DAVIESS COUNTY FISCAL COURT

ADDENDUM NO. 3

May 21, 2024

Office Renovation

1 Finish Plan
1/8" = 1'-0"

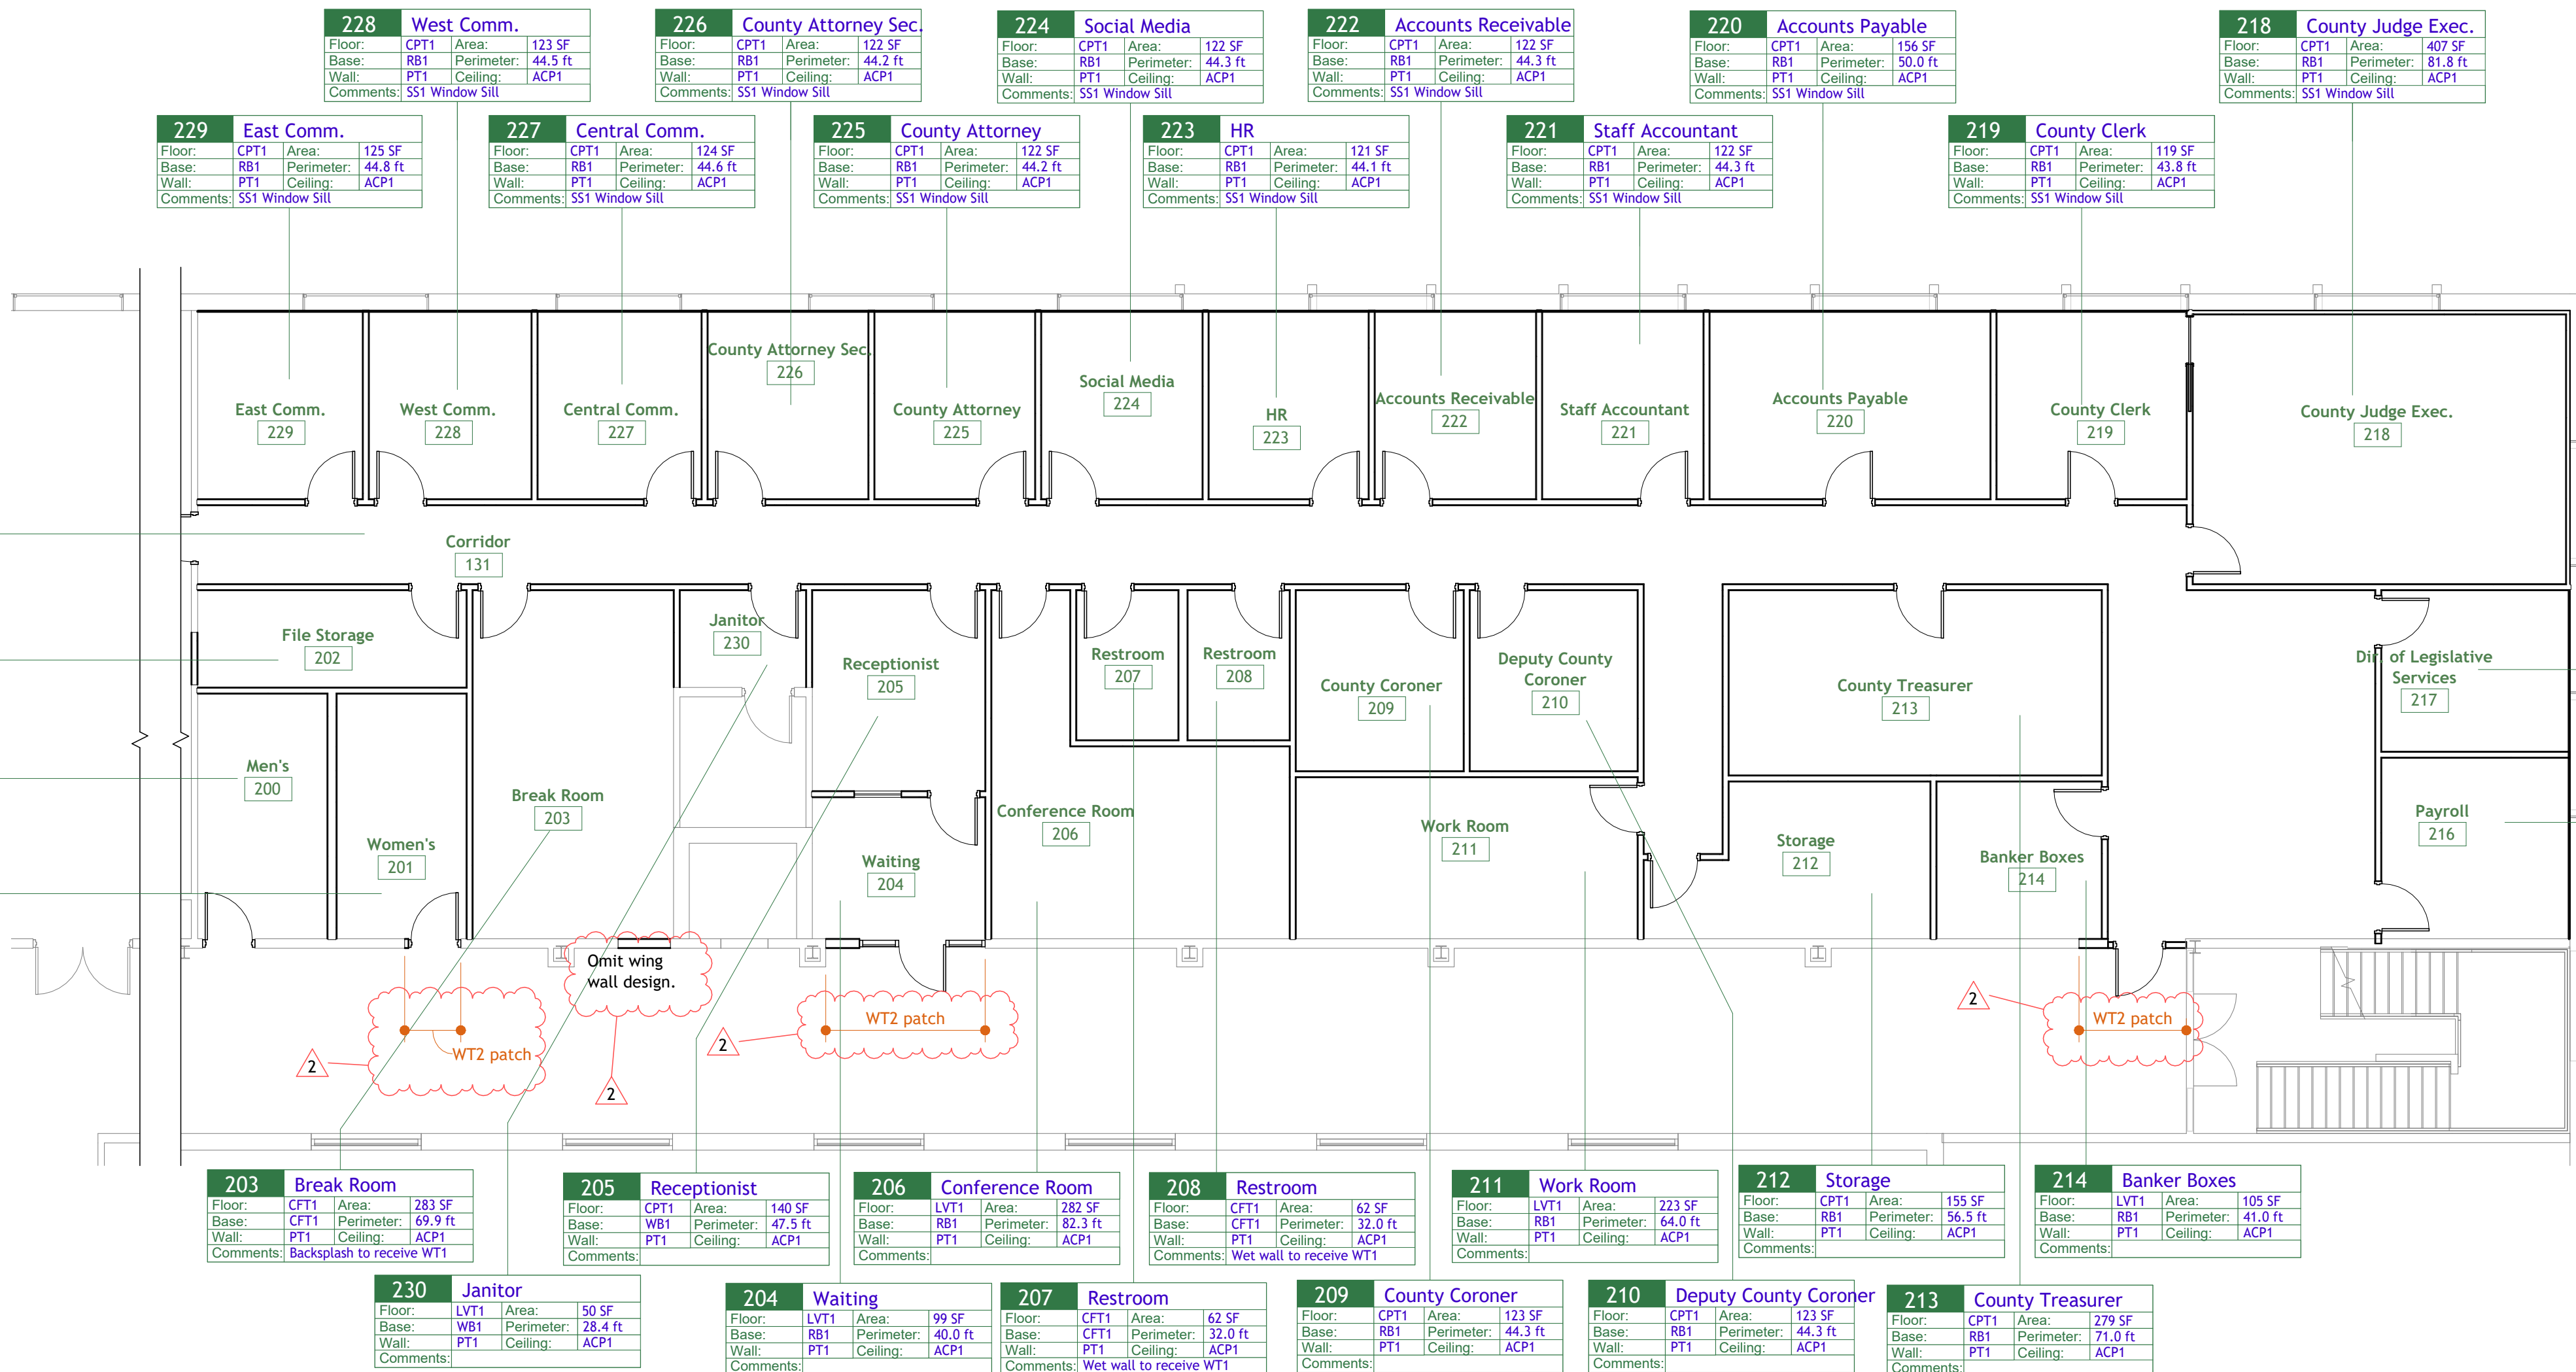
- Clarification on Finish Plan drawings (see attachment) calling out matching existing tile in corridor.
- Clarification on Finish Plan drawings (see attachment) showing tile only on wet walls.

- Access control wiring will be through a county contractor. Conduit, boxes, and pull string by general contractor.
- The base in rooms 205 and 230 should be RB1.

131	Corridor
Floor: LVT1	Area: 1,099 SF
Base: RB1	Perimeter: 367.1 ft
Wall: PT1	Ceiling: ACP1
Comments: SS1 Window Sill

200	Men's
Floor: CFT1	Area: 129 SF
Base: CFT1	Perimeter: 47.7 ft
Wall: PT1	Ceiling: ACP1
Comments: Wet wall to receive WT1

201	Women's
Floor: CFT1	Area: 129 SF
Base: CFT1	Perimeter: 47.7 ft
Wall: PT1	Ceiling: ACP1
Comments: Wet wall to receive WT1

206	Conference Room
Floor: LVT1	Area: 282 SF
Base: RB1	Perimeter: 82.3 ft
Wall: PT1	Ceiling: ACP1
Comments: Wet wall to receive WT1

208	Restroom
Floor: CFT1	Area: 62 SF
Base: CFT1	Perimeter: 32.0 ft
Wall: PT1	Ceiling: ACP1
Comments: Wet wall to receive WT1

1 New Ceiling Plan

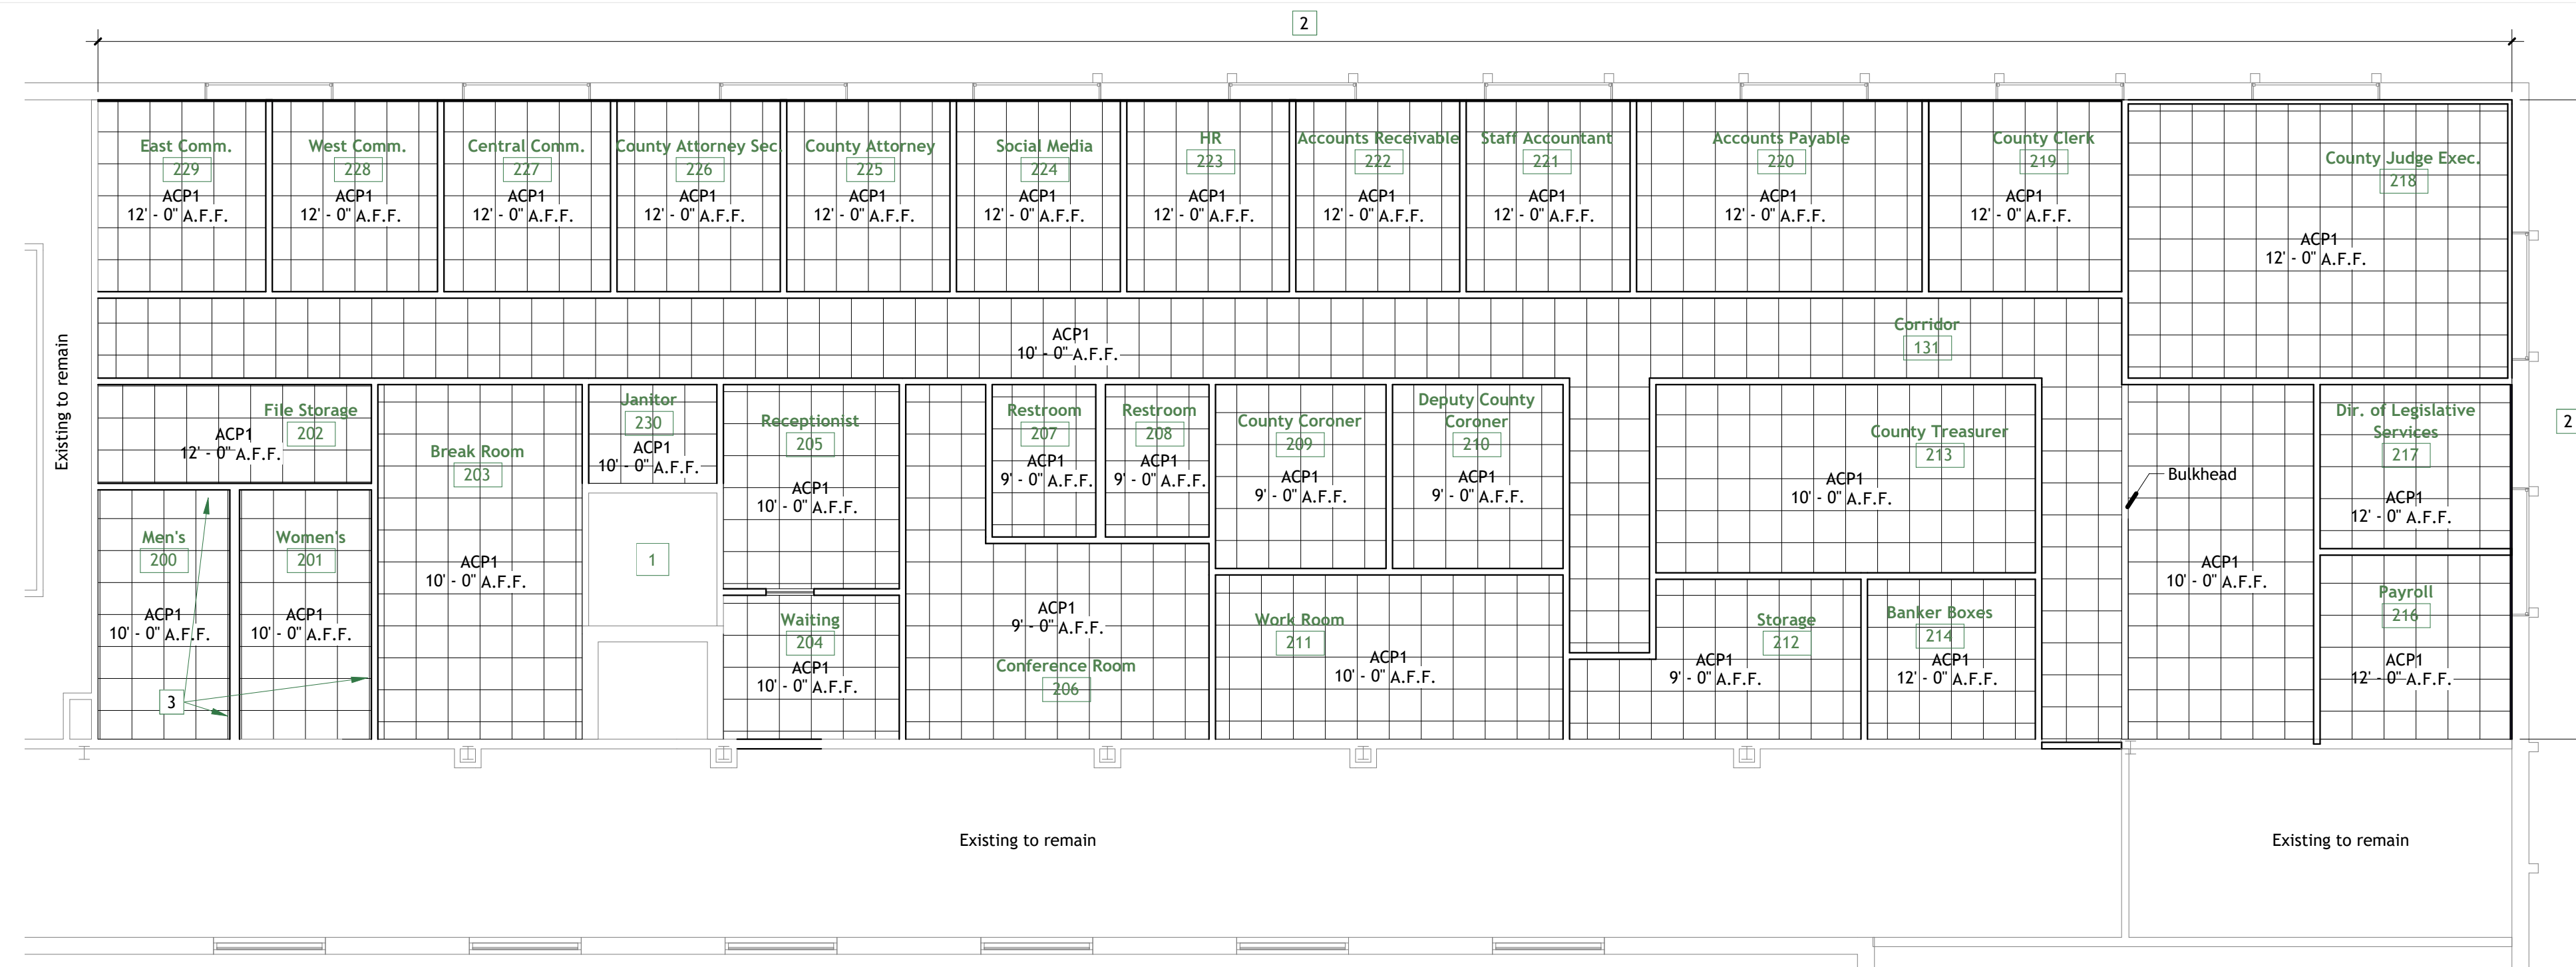
- No new ceiling grid in basement or Coroner's Office.
- Asbestos abatement will be contracted directly through Fiscal Court and scheduling to be done by general contractor.
